CITY OF CHARLOTTESVILLE
DEPARTMENT OF NEIGHBORHOOD DEVELOPMENT SERVICES
STAFF REPORT TO THE ENTRANCE CORRIDOR REVIEW BOARD (ERB)

ENTRANCE CORRIDOR (EC)
CERTIFICATE OF APPROPRIATENESS

Project Name: 1801 Hydraulic Road, Hillsdale Place

Building Elevations
Scale: 3/32"=1'-0"

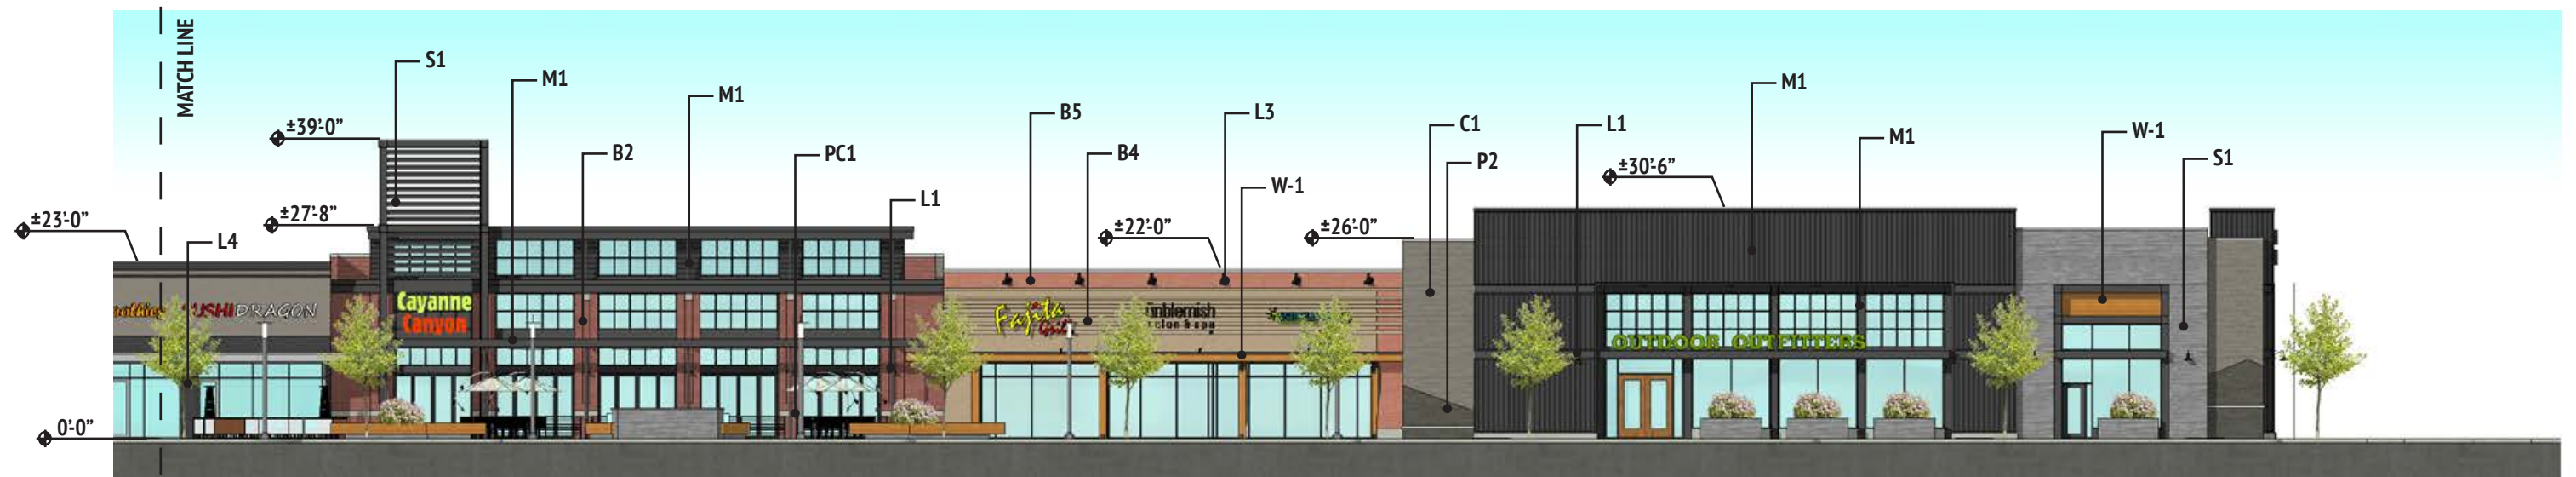
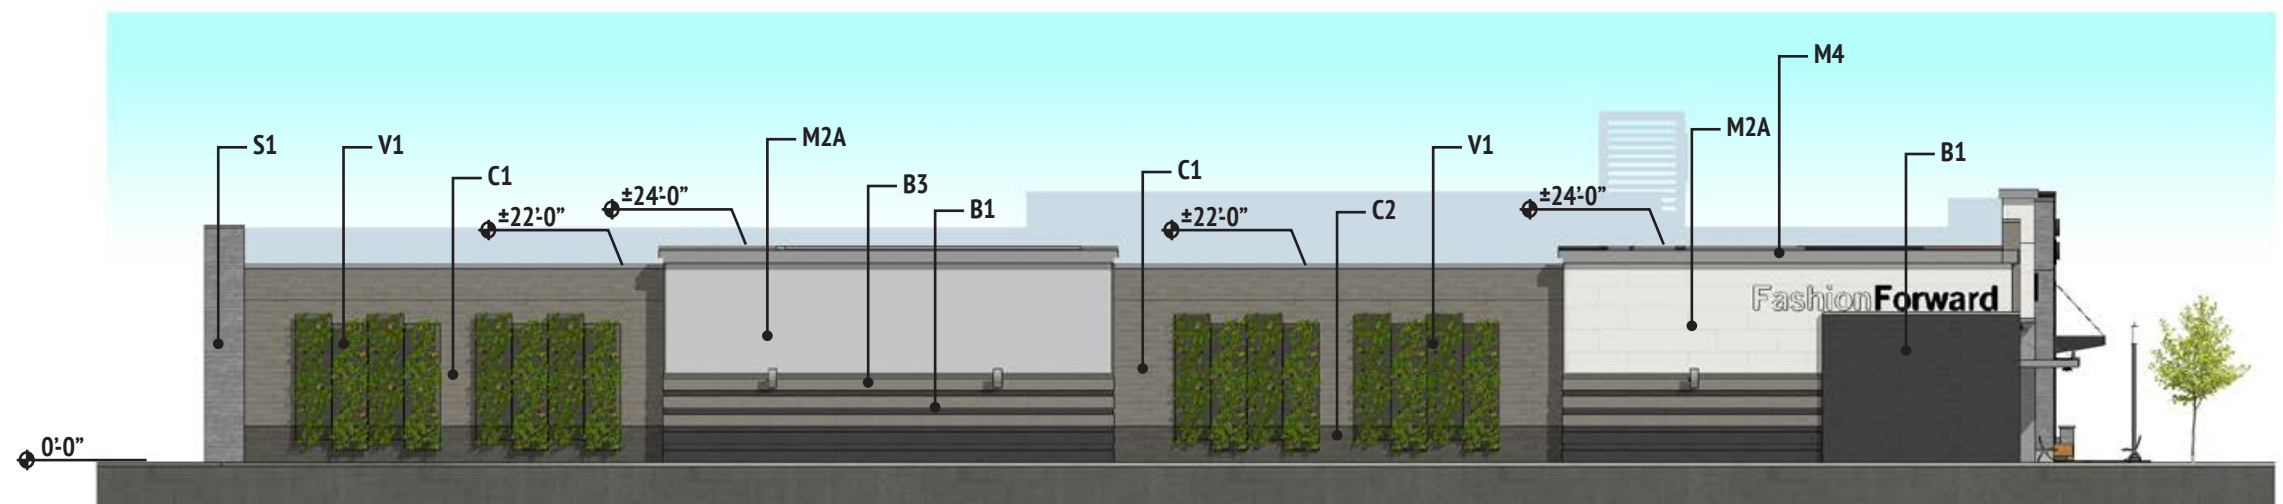
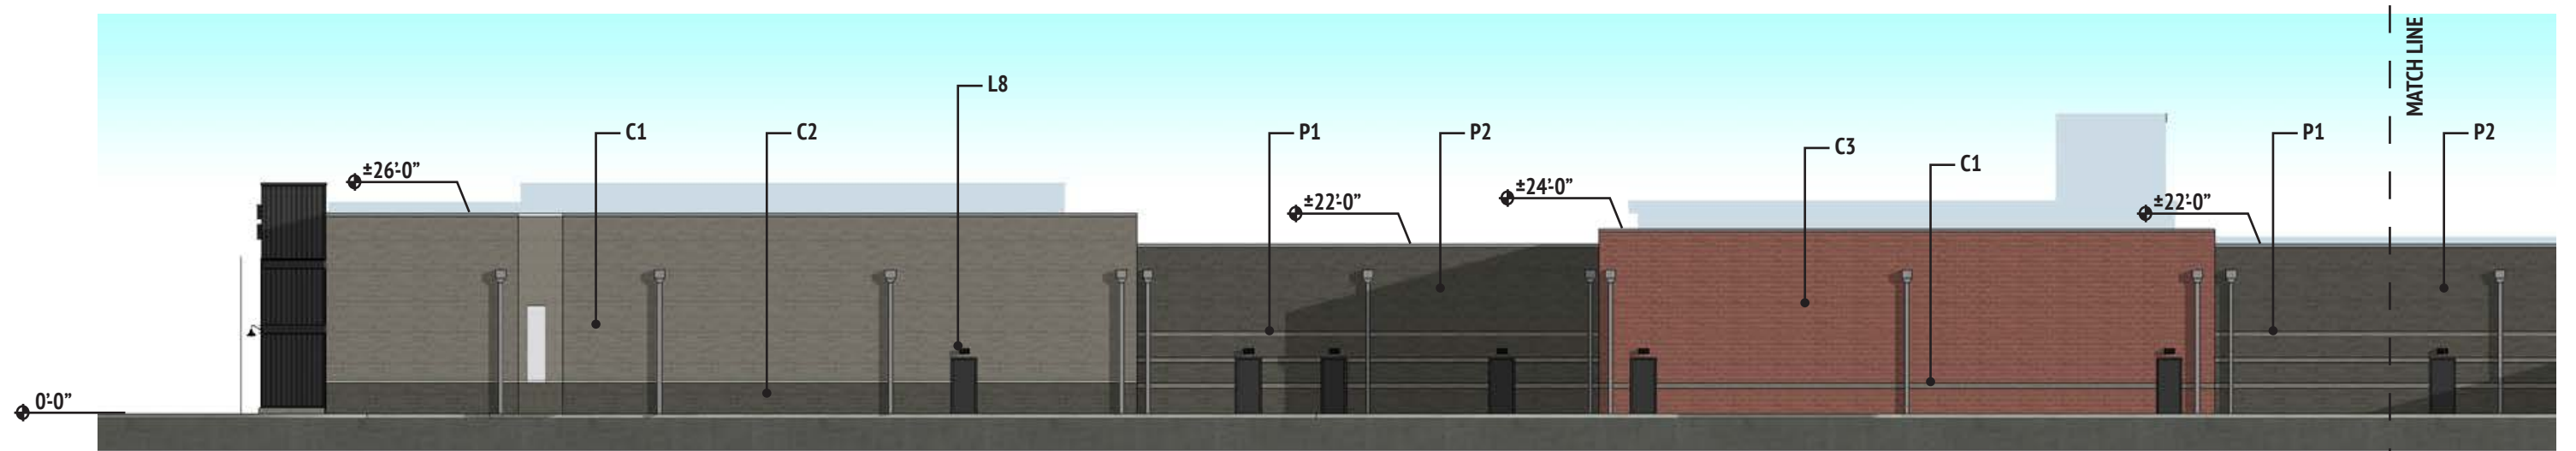
The facade that faces Route 29 has no glass, but is otherwise articulated with color, materials, and vegetated wire trellis.

The Hillsdale Road façade has glass only at the entryway. That wall is mostly split face block that is not well-articulated, given its visibility from Hydraulic Road.

Staff recommends additional articulation, preferably using more brick, on the Hillsdale Road façade (the existing facade is currently painted brick and CMU) to complement the Whole Foods building.

1. Additional articulation on the Hillsdale Road façade, preferably using more brick;
2. Signage requires separate permits. All signage shall appear to be lit white at night.
3. The L-7 fixture shall not be used to outline the building, unless the light source is fully concealed, and not mounted above 20 feet height.
4. All glass must be specified as clear, with minimum 70% visible light transmittance (VLT).
5. A pedestrian walkway shall be added along the main entry drive from the Hydraulic Road City sidewalk to the building plaza area, and a City sidewalk shall be added to the south side of India Road from Route 29 to the walkway on the west side of the building.

Proposed Fixtures

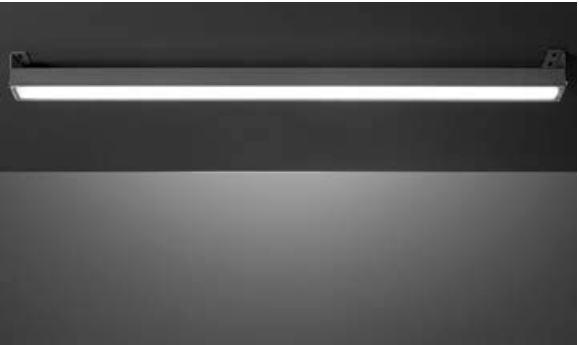
New lighting, including building and pole lighting, may not exceed twenty feet mounting height. The fixtures all appear to be dark sky-friendly, but staff has requested cut sheets to verify. Staff does not recommend the use of L-7 to outline the building, unless the light source is fully concealed. It may not be mounted above 20 feet height.
